Sundry Print Report

Well Name: BERGER A Well Location: T26N / R11W / SEC 21 / County or Parish/State: SAN

Subsequent Report

Type of Action: Plug and Abandonment

Current Schematic - Version 3

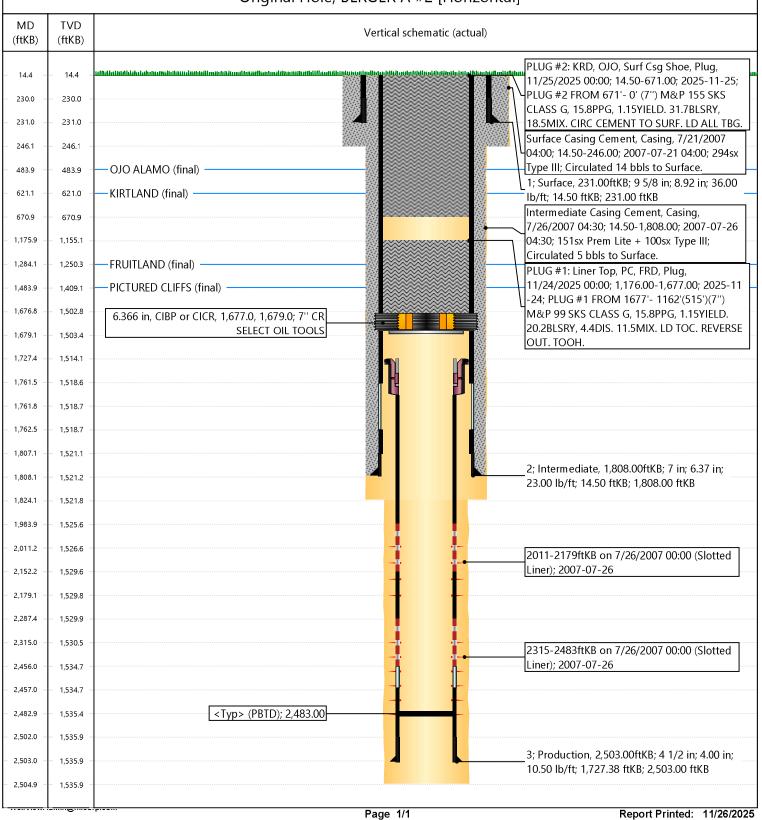
The BERGER A 2 (3004532998) P&A NOI was previously submitted and approved under the assumption it was a vertical well, however, it is a horizontal well. So, we are requesting to modify where the CIBP is set, and where the first plug is pumped. I have attached the updated proposed P&A procedure, along with the original approved NOI.

- Move the CIBP/CICR from 1,961' to 1,677'.
 - o This moves the CIBP/CICR to 50' above the liner top.
 - o This puts the CIBP/CICR being set at ~73°, see Directional Survey attached.
- Plugs 1 and 2 will be combined to cover from the CIBP/CICR to above the Fruitland.
 - o 1,677' 1,184' (Liner top, PC, FRD).
- Plug 2 (previously plug 3) remains unchanged.

NMOCD agrees

BLM finds the updated procedure appropriate.
